UNITED STATES PATENT AND TRADEMARK OFFICE

10/598,848

Office Action Summary	Application No. 10/598,848	Applicant(s) LINDLBAUER, FRANZ	
	Examiner ANDREW PERREAULT	Art Unit 4177

DETAILED ACTION

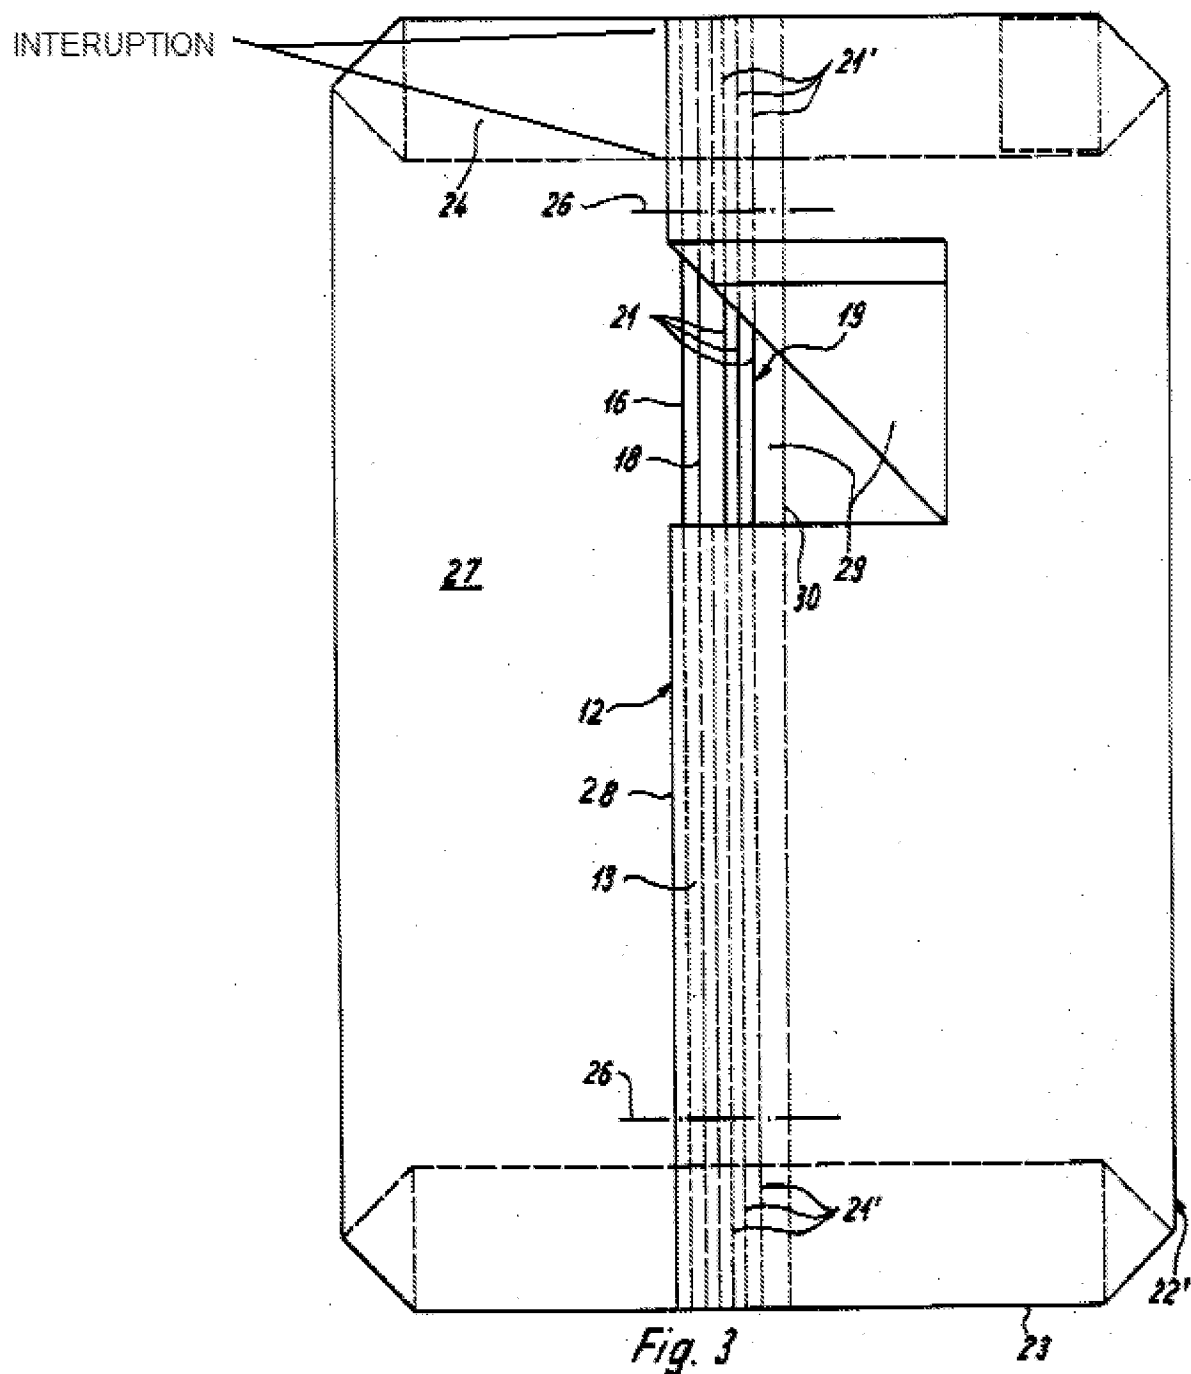
10. As to claim 10 and 18, as best understood, Combrink discloses a multilayer, sack packaging medium 22' (fig. 3), comprising a front side and a rear side joined (as seen in fig. 3) by first and second side areas (sack 22' inherently has a front, rear, and two sides; fig. 3), and closed at an upper end 24 and a lower end 23 (fig. 3), an opening 25 (fig. 2, 3) for filling, being free at the upper end 24, the packaging medium 22' having an inner wall 14 (col. 7, lines 1-19; fig. 2, 3) surrounded by an outer wall 15 (col. 7, lines 1-19; fig. 2, 3), comprising a plastic film ("thermoplastic sheet," col. 7, lines 9-13); wherein on the front side, the outer wall 15 overlaps a subregion 13 of up to 50% of the total area of the front side (fig. 3); at edges of the overlap region 13, the two walls 14, 15 lying one above the other are joined to each other by means of seams, forming a joint 12 (col. 5, line 37-40; fig. 2, 3); at one edge, the joint 12 is interrupted over a continuous region which covers 10 to 50% of the total length of the joint 12 (see fig. 3 below); 10 to 50% of the area of the overlap region 13 is provided with perforations 20 (col. 7, lines 1-9; col. 5, lines 57-65; fig. 2, 3); but does not disclose that a distance of 0.5 to 10 cm from the edges of the overlap region 13 is maintained, the inner and outer wall material, and that the inner layer of the outer wall is perforated. However, it would have been obvious to one having ordinary skill in the art at the time the invention was made to modify the distance such that the distance of 0.5 to 10 cm from the edges of the overlap region 13 is maintained, since it has been held that discovering an optimum value of a result

11. As to claim 11, Combrink discloses that the outer wall 15 overlaps only on the rear side (fig. 3).

12. As to claim 12-13, Combrink discloses the outer wall 15 overlaps (with overlap region 13) over its entire length (fig. 3).

13. As to claims 14-16, as best understood, Combrink discloses that the interruption is in the upper half of the packaging medium 22' (see fig. 3 above).
